VEIRS MILL

Planning Board Work Session #5
October 4, 2018

MATTHEW HENSON TRAIL CROSSING

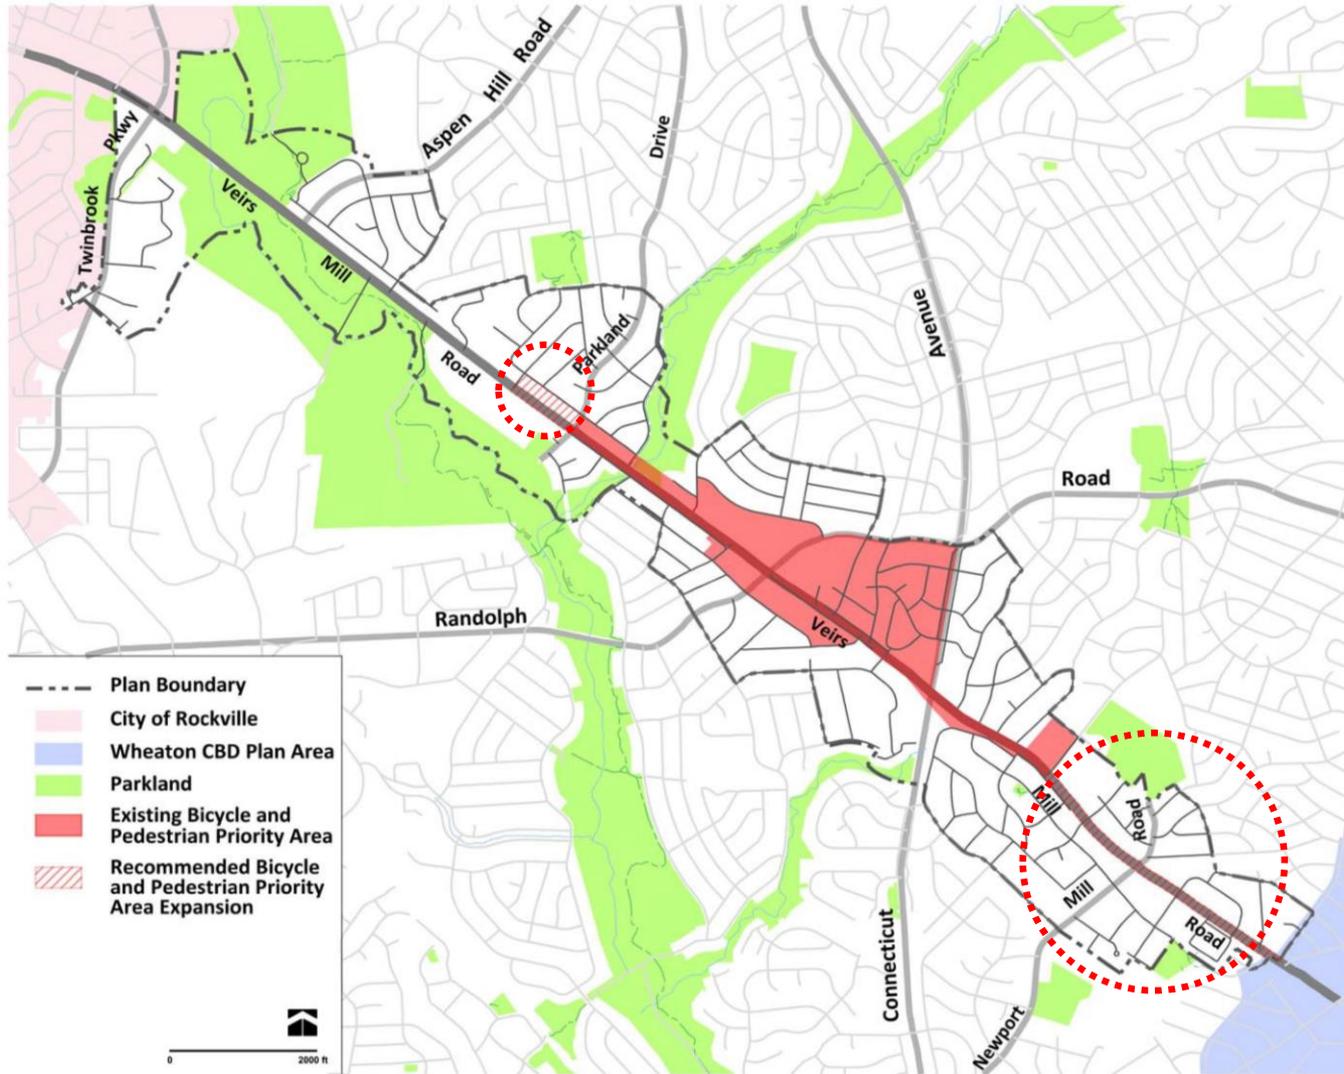
- Provide the following improvements for the Matthew Henson Trail crossing of Veirs Mill Road:
 - Provide a protected crossing that eliminates conflicts and has a high rate of compliance. A first step is a full traffic signal or similar device, but additional enforcement such as red-light cameras may be needed. ~~Install a full traffic signal to improve safety for pedestrians, bicycles, transit users and motorists.~~ This is the highest priority protected crossing signal recommended by this master plan.
 - Introduce additional pedestrian-scale lighting to improve visibility at the crosswalk and within the pedestrian refuge island.
 - In the long-term, provide a grade separated crossing of Veirs Mill Road ~~in the long term~~ for users of the Matthew Henson Trail and preserve a protected at-grade crossing.
